**City of Fairhope  
Planning Commission Agenda  
5:00 PM  
Council Chambers  
December 2, 2024**

### SR 24.06 - Express Oil Change

RE: SR24.06 Express Oil Change at Planter's Pointe

Figure 2: East "False Front" Elevations. Sheet A200 of Building and Construction Plans.

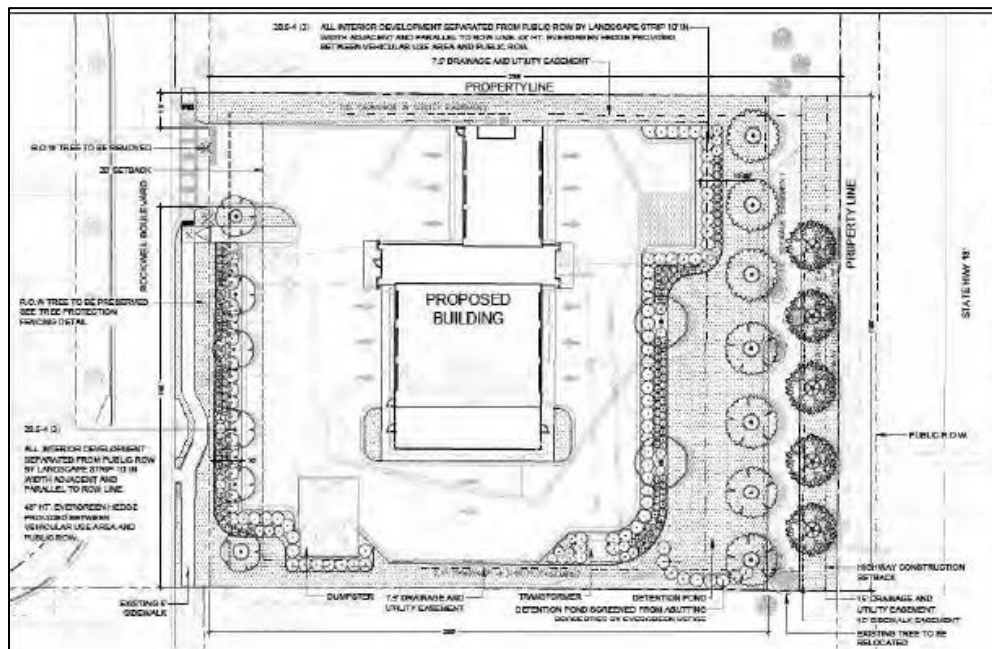
**Building:** Building height for the one-story structure is estimated at 24ft. The proposed 5,747sf building takes up 13% of Lot 8. Proposed use is a national automotive chain. Complete build-out information and details are provided as attachments as well as the elevations. False front (East) elevations are shown in Figure 2. Materials for the building are painted concrete aluminum doors/windows.

Figure 4: Sheet LA5.00.

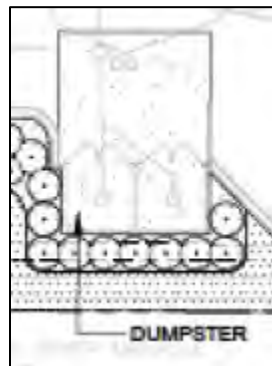
- There are some inconsistencies with notes on Sheet LA5.00 and the actual plants on the sheet. For example, there are five (5) overstory trees required at the Rockwell Blvd property line. The notes read there are what looks like eight (8) provided when there are only six (6). The square footage of the entire site is different from what is on the Site Data Table provided on the Site Layout sheet.

- It is unclear how high the evergreen hedges will be at planting that are screening the dry detention pond pursuant to Section 20-5.4(11) of Ordinance No. 1444. The evergreen hedge must be at least 36 inches in height at time of planting.

2. ***Do not remove trees facing AL Hwy 181.*** We have designated the existing trees to be moved out of the sidewalk easement and placed generally where they were intended to be. This correction can be seen on Sheet LA5.00. We have also attached Frank Leatherwood's, the engineer of record for Planter's Pointe, provided landscape plan that we used as guidance ("Pages from 20240214\_Landscape Plan\_Record Drawing\_Revised")

Figure 5: Sheet C5.1.

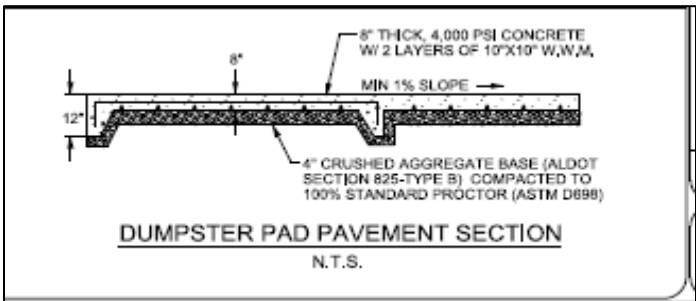
**Dumpster location and screening:** Garbage is collected in two (2) commercial dumpsters located west of the Loading/Unloading Area. The dumpsters are partially enclosed by plantings and a screen wall.
